RE: Well Violation Review
North Carolina Well Construction Standards
Charles Rader Well
Mecklenburg County, N.C.

WELL ABANDONMENT RECORD

Re: NOTICE OF VIOLATION
NORTH CAROLINA WELL CONSTRUCTION STANDARDS
Charles Rader Well
Mecklenburg County, N.C.

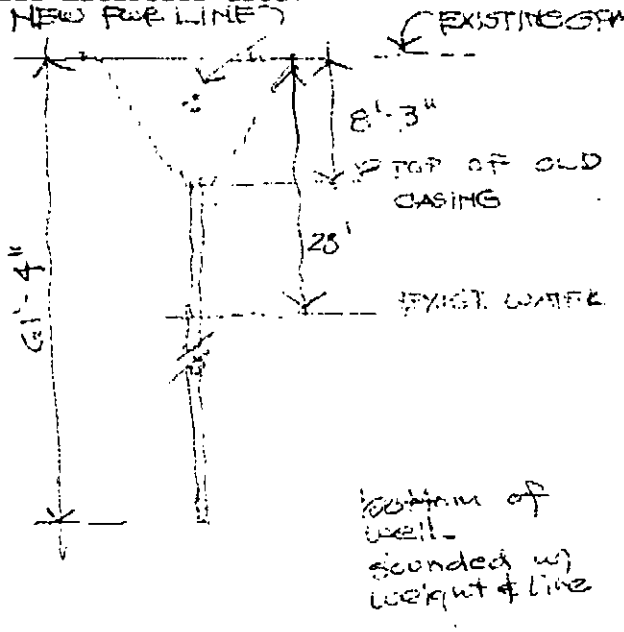
The well not been abandoned in accordance with Commission Rule 15A NCAC 2C .0113(2).

Review of the well abandonment record indicated that the well construction violation had been corrected. Due to your timely response to the Notice, no enforcement action will be recommended at this time.

WELL ABANDONMENT RECORD

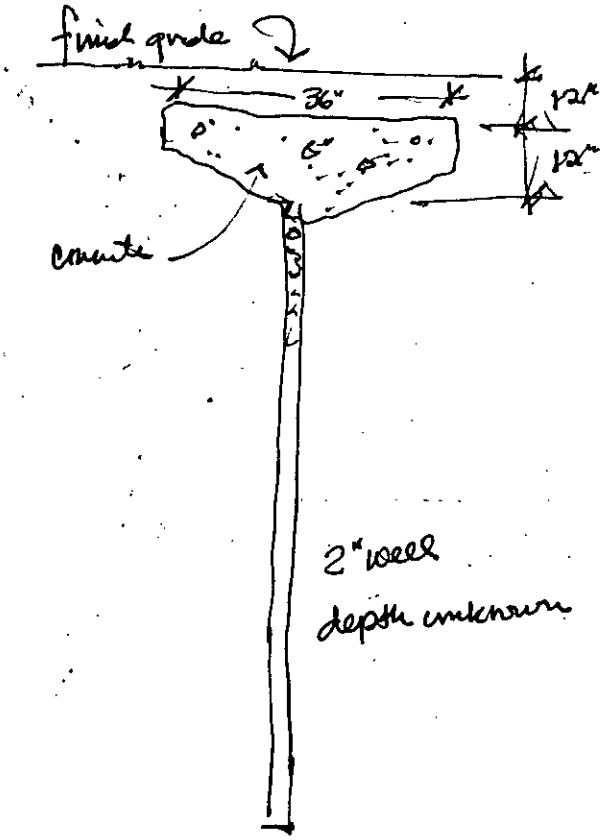
Specifically, staff of the Mooresville Regional Office reviewed the Well Abandonment Record (GW-30) submitted for a well at the residence owned by Charles Rader located at 16634 Yacht Road (formerly Wally Road), Mooresville 28115-6639 in Mecklenburg County, North Carolina. Said well was abandoned or caused to be abandoned by Chris Holcombe. Review of the record revealed that:

The well was not abandoned in accordance with Commission Rule 15A NCAC 2C. 0113(2).

In accordance with G.S. 87-94, Chris Holcombe may correct the above cited violations and thereby avoid enforcement action if the violation is corrected by performing the following within 30 days of receipt of this notice:

1. Properly abandon the well in accordance with Commission Rule 15A NCAC 2C. 0113(2).

2. Submit a well abandonment record to the MRO in accordance with Commission Rule 15A NCAC 2C. 0114(b).

PROPOSED PLOT PLAN

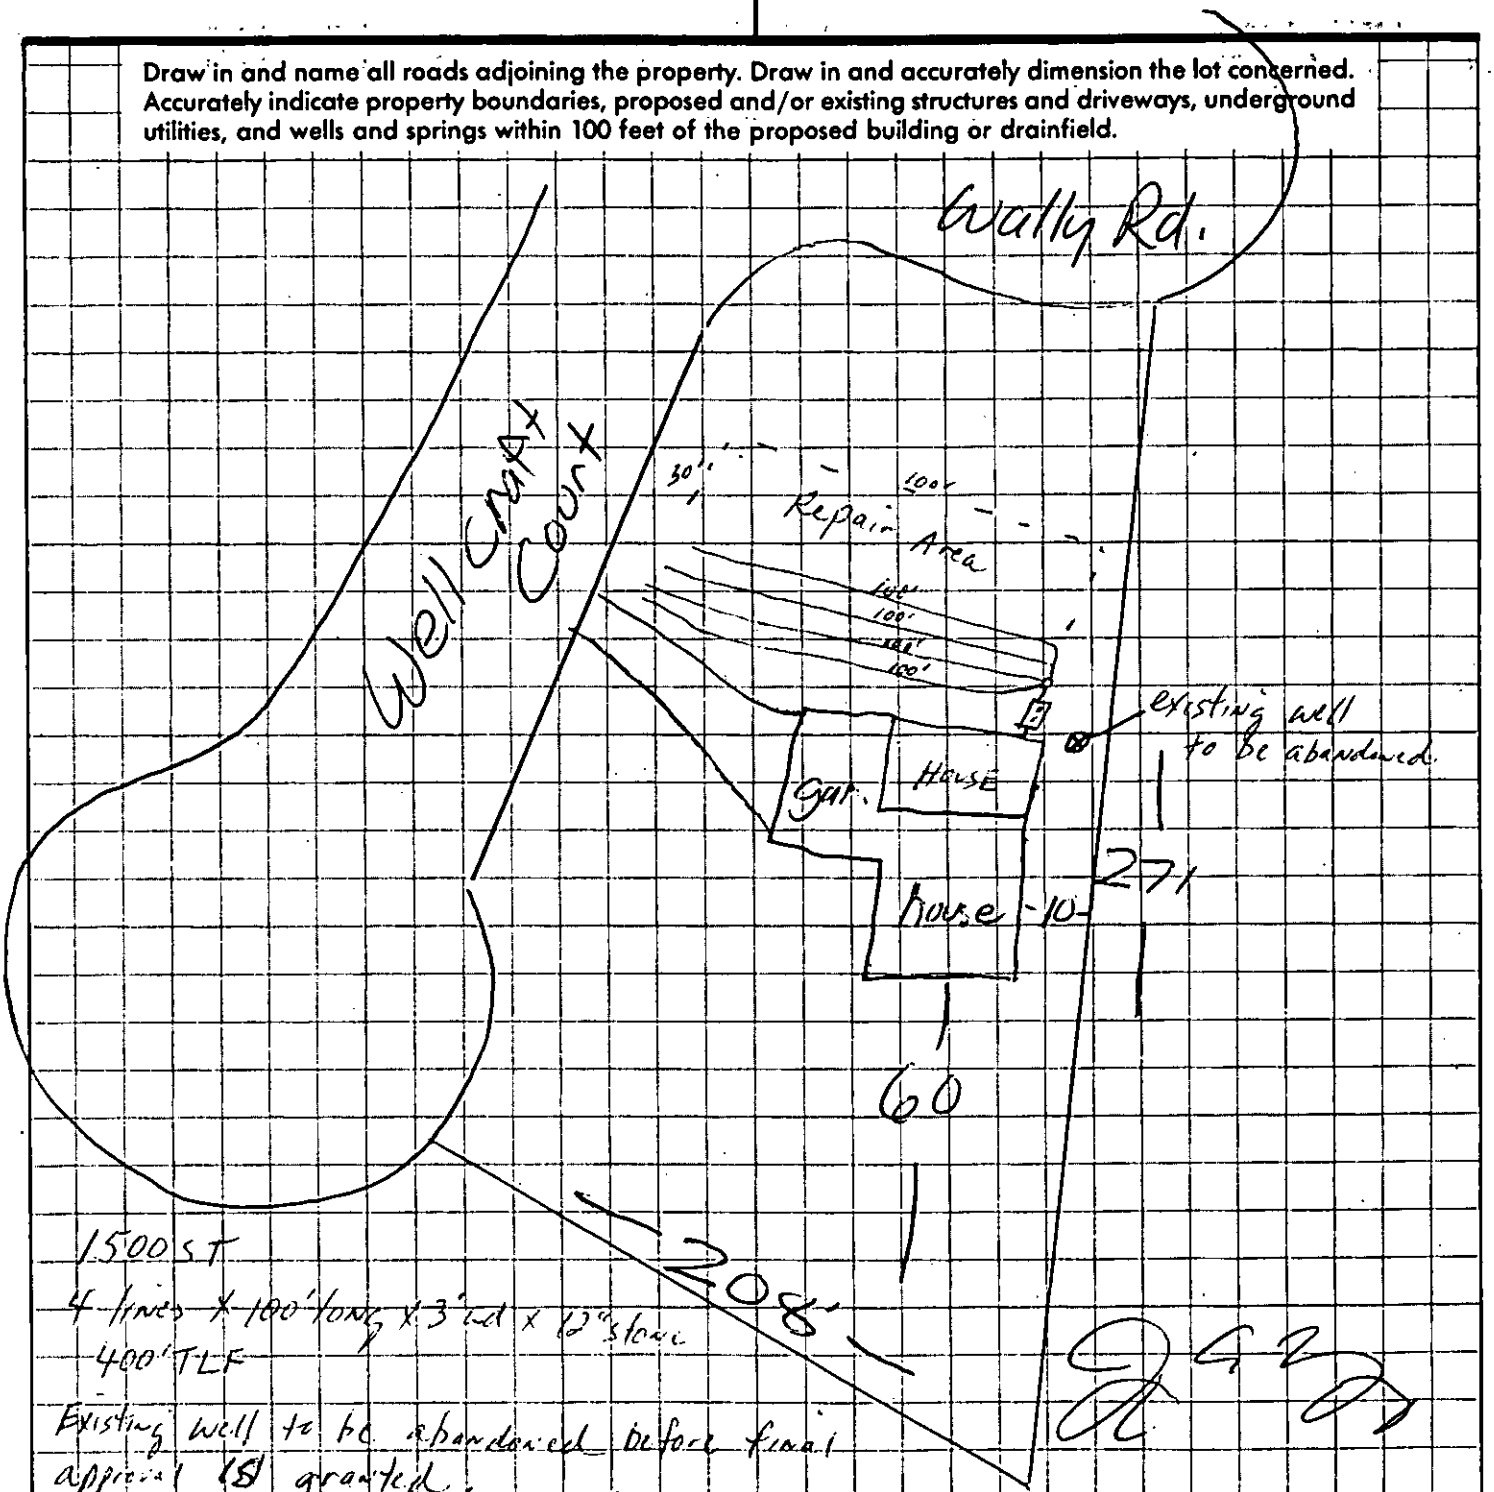
Existing well to be abandoned before final approval is granted.

Keep proposed well >50 from septic system
